July 8, 2013

RE: CUYAHOGA COUNTY  
VILLAGE OF WALTON HILLS  
CONSTRUCTION STORM WATER  
PERMIT NO: 3GC06451\*AG  
MANTUA MANUFACTURING  
**NOTICE OF VIOLATION**

Figure 1: Outlet structure is not complete. It resembles that of a sediment pond rather than a sediment trap.

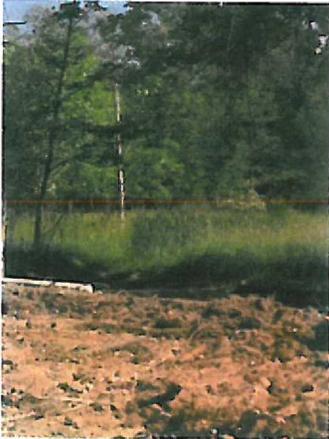
- The outlet structure of the sediment basin resembled that of a sediment pond rather than that of a sediment trap, which was the sediment control basin indicated on the SWP3. (Figure 1)The SWP3 will need to be edited to show a sediment pond outlet structure and include necessary calculations of the sediment storage zone and dewatering zone, in addition to the calculation of the drawdown time and an appropriately sized orifice, as opposed to the sediment trap that the SWP3 currently shows.

Figure 2+3: Discharge into a wetland requires a level spreader.

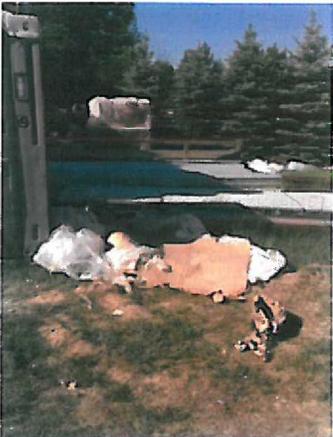
- It appears that the sediment trap discharges into a wetland behind the property. (Figures 2+3) **Please note that a separate permit from the Army Corps of Engineers is required to discharge into a wetland. In addition the permit reads that concentrated storm water runoff from BMPs to natural wetlands shall be converted to diffuse flow before the runoff enters the wetlands. Discharge should be released such that no erosion occurs downslope. Level spreaders may need to be placed in series, particularly on steep sloped sites, to ensure non-erosive velocities.** By extending the current rip rap to resemble a level spreader, this requirement can be met.

Figure 4: Trash must be in a covered dumpster.

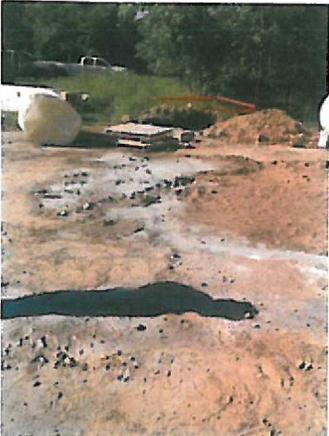
- **Non-sediment pollution controls require repair and maintenance as per the NPDES Permit.** The concrete washout pit did not have a plastic liner. A plastic liner is essential in preventing an unauthorized discharge of wastewater to the environment. **ALL concrete wash out is to occur ONLY at the washout pit location.** (Figure 5) Runoff from the concrete mixing area must be collected either by creating a berm around the area or by grading the area toward the concrete washout pit. There was no trash dumpster on site at the time of our inspection. Note that trash must be placed in a covered dumpster. (Figure 4)
